# COMMUNITY DEVELOPMENT DEPARTMENT REPORT

HEARING DATE: 5/7/2026

SUBJECT: Ustick Commercial  
H-2025-0059 (CPAM); H-2026-0007 (AZ, PP)

LOCATION: 5900 W. Ustick Rd., in the southwest 1/4 of Section 33, T.4N., R.1W.

**E. Conceptual Development Plan**

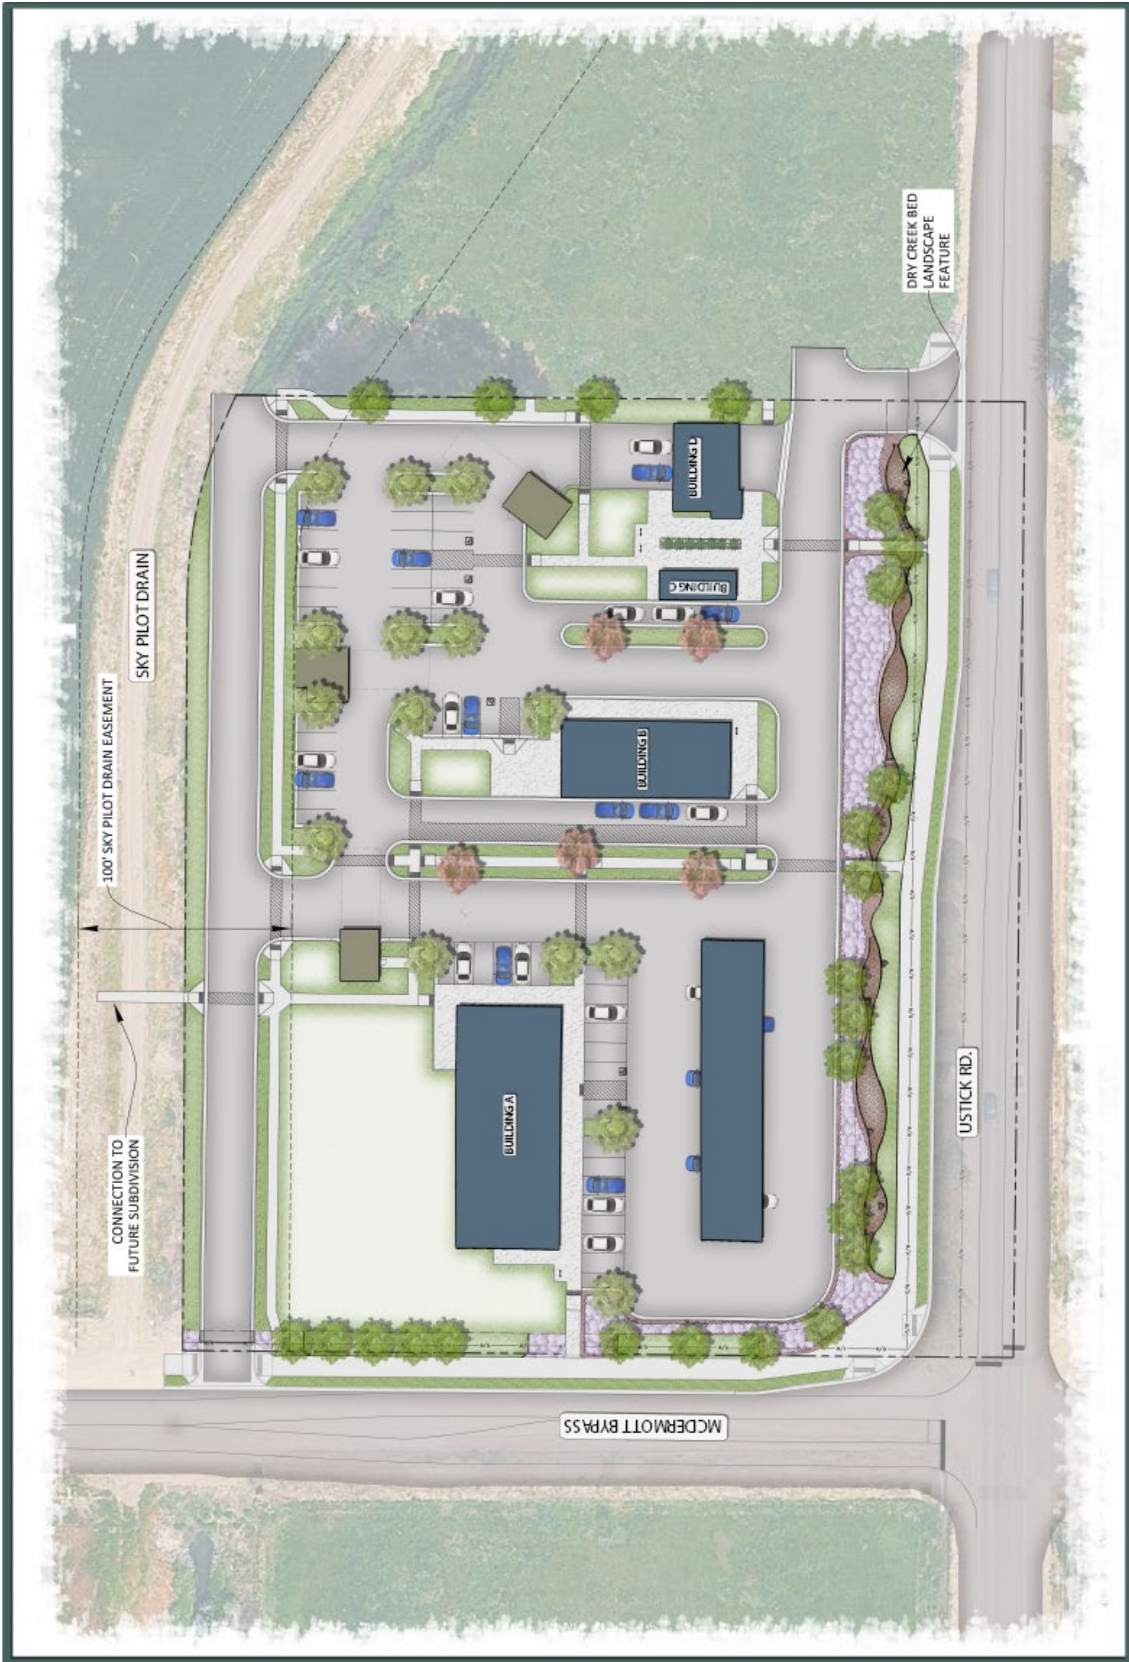
The conceptual development plan depicts an interconnected network of walkways and drive aisles that promote pedestrian and vehicular mobility within the development and to the adjacent development to the east; a pathway is proposed to the future residential development to the north for pedestrian access and connectivity, no vehicular connectivity is proposed.

For lots with frontage on a public street, a minimum of thirty (30) percent of the buildable frontage of the property shall be occupied by building facades and/or public space per UDC 11-3A-19B.2b. A drive aisle is proposed along the frontage of the property adjacent to Ustick Rd., which separates the buildings from the street – parking is proposed at the rear of the buildings. **If the proposed development is approved, compliance with this standard is required. A revised conceptual development plan should be submitted that demonstrates compliance with this standard.**

Pedestrian pathways are proposed from the perimeter sidewalk to the main building entrances. **Where the pathway crosses vehicular driving surfaces, it is required to be distinguished through the use of pavers, colored or scored concrete, or bricks, per UDC 11-3A-19B.4b.**

2. Access (*UDC 11-3A-3, UDC 11-3H-4*):  
One (1) full access is proposed via N. McDermott Bypass on the west side of the site at the north boundary; and one (1) right-in/right-out temporary access is proposed via W. Ustick Rd. at the east boundary of the site. The McDermott Bypass is currently under the jurisdiction of ITD but is expected to be turned over to ACHD at some point in the future. ITD has stated they won't support access via McDermott Bypass.

Staff is not supportive of an access via W. Ustick Rd. ACHD states that the TIS did not demonstrate a need for this driveway. Further ACHD, like City policy, requires access to be taken from lesser-classified roadways, which is McDermott Bypass; a collector roadway once under the jurisdiction of ACHD.

Drive aisle stubs are proposed to the property to the east but no vehicular connectivity is proposed to the future residential development to the north. **If approved, Staff recommends a drive aisle connection be provided to the north for interconnectivity with the residential neighborhood. Cross-access/ingress-egress easements are required between all lots in the subdivision and to adjoining properties either by recorded easement or as a note on the final plat as set forth in UDC 11-3A-3A.2.**

## J. Conceptual Building Elevations

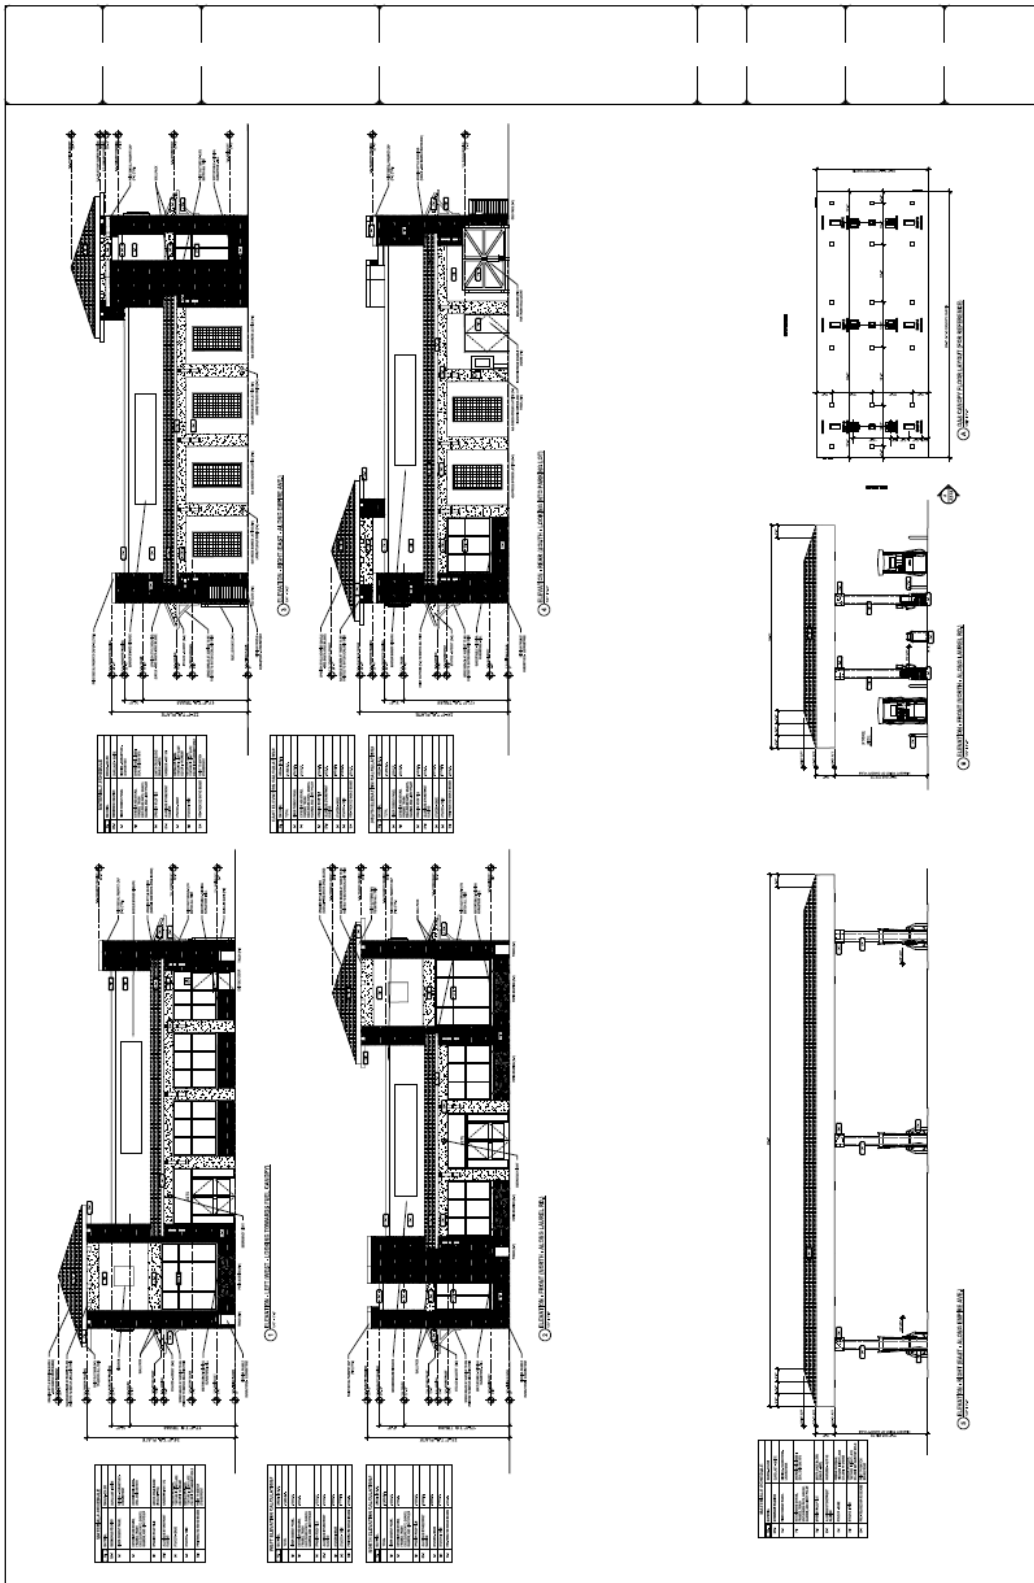
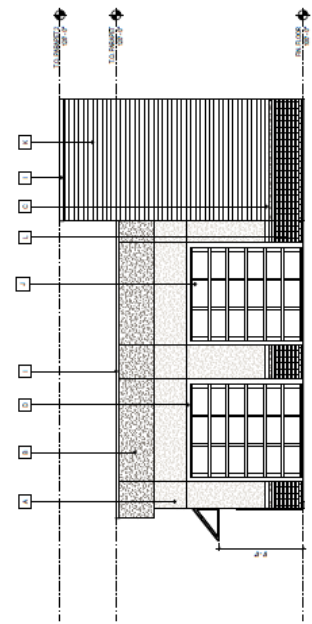
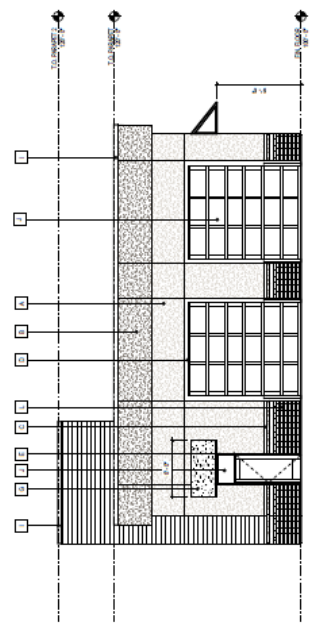
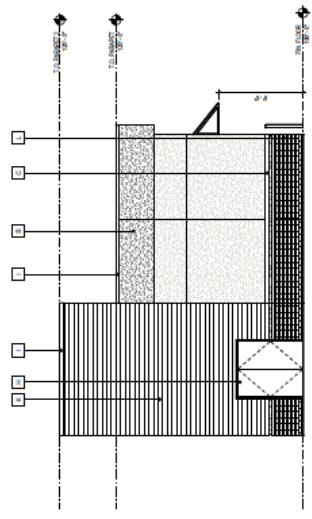
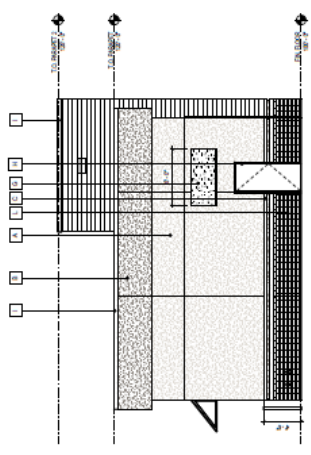
Conceptual building elevations were submitted for the proposed convenience store, fuel canopy, coffee shop and oil change facility as shown below in Section VII.J. All structures are proposed to be a single story in height. **Final design is required to comply with the design standards in the Architectural Standards Manual (ASM).**
